## **ADDENDUM NO. 1**

**New Pavilion  
Missouri Veterans Home  
Mount Vernon, Missouri  
PROJECT NO.: U2417-01**

**Bidders are hereby informed that the construction Plans and/or Specifications are modified as follows:**

C-101

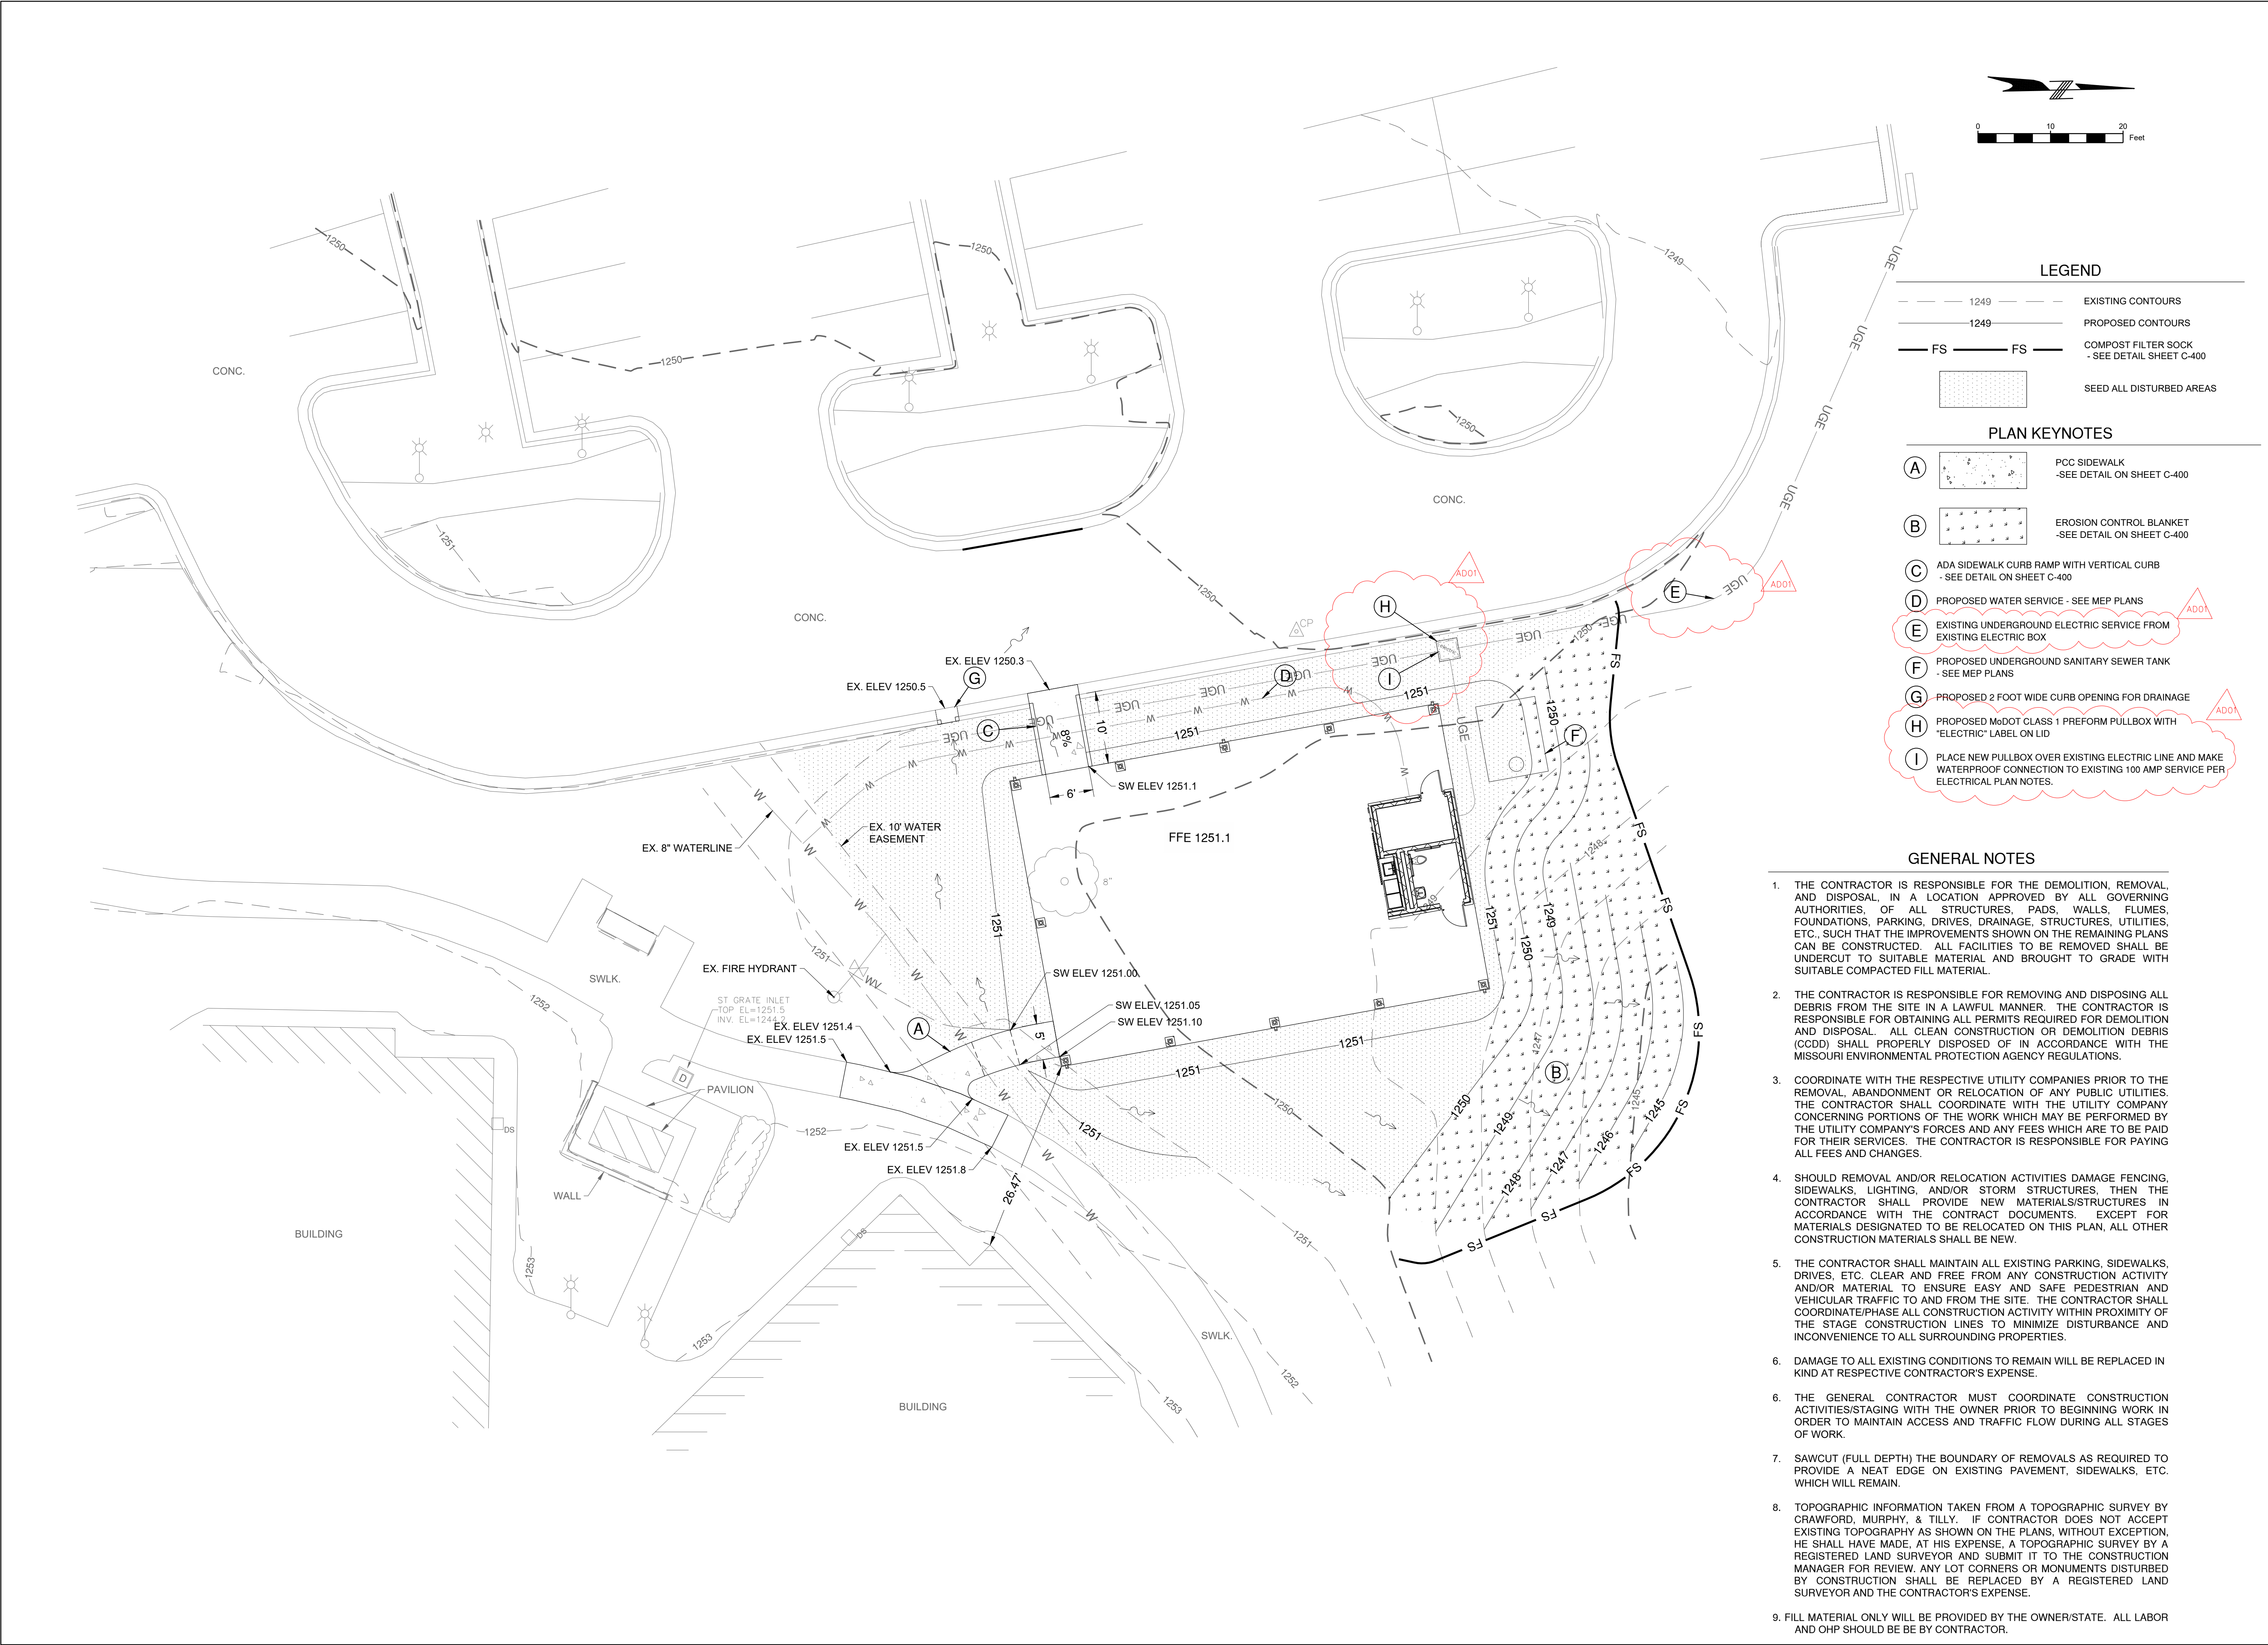
1. SHEET C101
  - a. ADD note calling out existing underground electrical line
2. SHEET C200
  - a. ADD note calling out existing underground electrical line and new pullbox in line connecting to the underground electrical line going to the new building.
3. SHEET C400
  - a. ADD Concrete and Preformed Pull Box details.
4. SHEET S201
  - a. REVISE notes on Sections 4, 5 and 6/S201 indicated by clouds.
